Docket Item # 4
BAR CASE # 2011-0011

BAR Meeting
January 26, 2011

ISSUE: Request for new construction of 21 townhouse units (17 single-family and 4 triplexes), 3 multi-family buildings and park, and waiver of rooftop screening requirement for Phase IV of the James Bland Redevelopment Project

LOCATION: 898 North Alfred Street

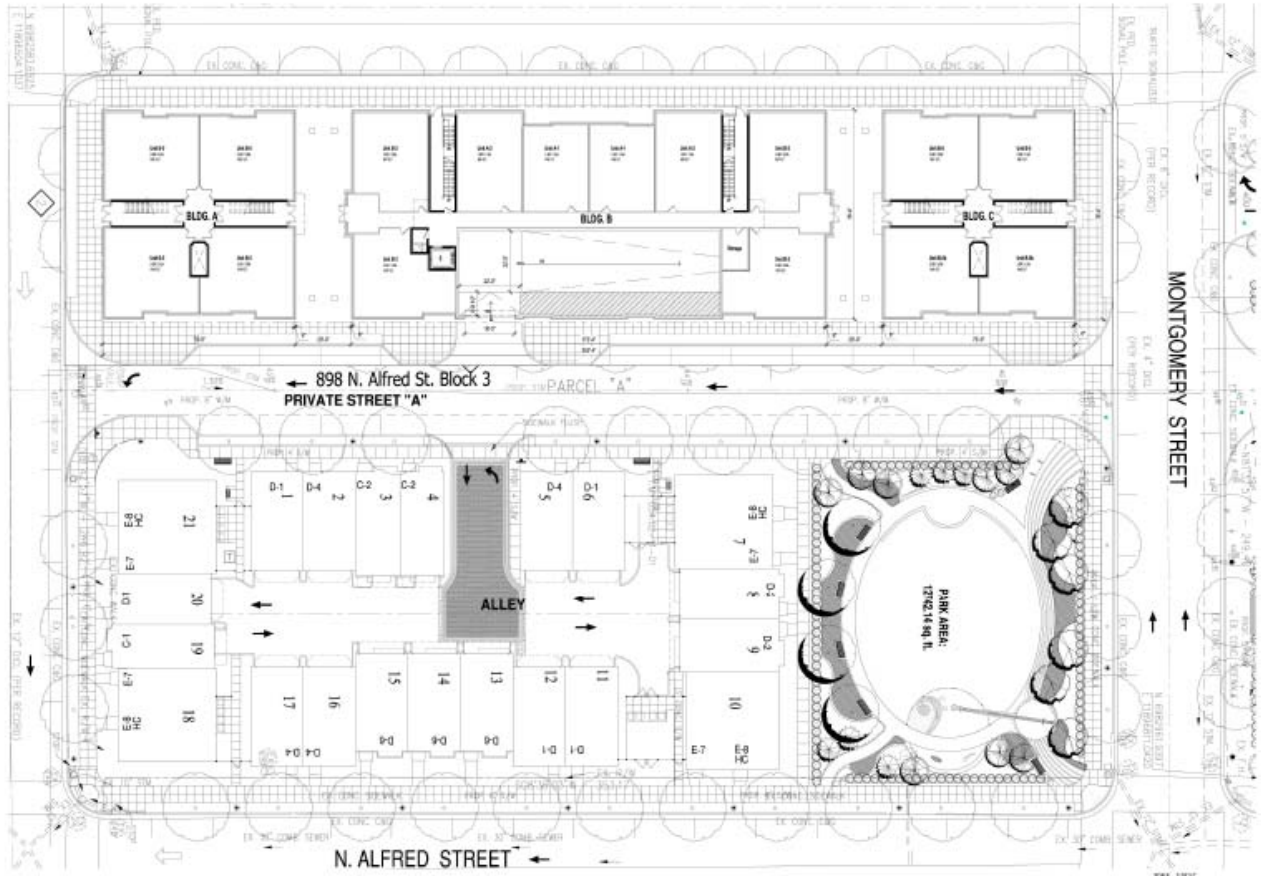
Multifamily Buildings

- o. Continue to work with Staff to enhance elevations of the multi-family buildings.
- p. North multifamily building: This building shall be refined by breaking its expression into subunits so that each of the architectural expressions has a consistent relationship to the geometry of the curved street, without modifying the footprint of the building.

- q. Architectural expression, multifamily buildings: the three proposed multifamily buildings shall be redesigned to the satisfaction of the Director, P&Z, such that each building expresses a clear and identifiable architectural style; further, the two south buildings shall be redesigned not to appear as twin buildings, and the north multifamily building shall be redesigned to express a smaller scale through subdivision of its mass into three visually distinct units.

- r. Entries at multifamily buildings: Building entries shall be designed to create a prominent and welcoming presence for all three buildings.
- s. The design of the multi family buildings shall be subject to the requirements herein to the satisfaction of the Director of P&Z and the issues shall be addressed prior to public hearing before the Parker-Gray BAR. (P&Z) (PC)
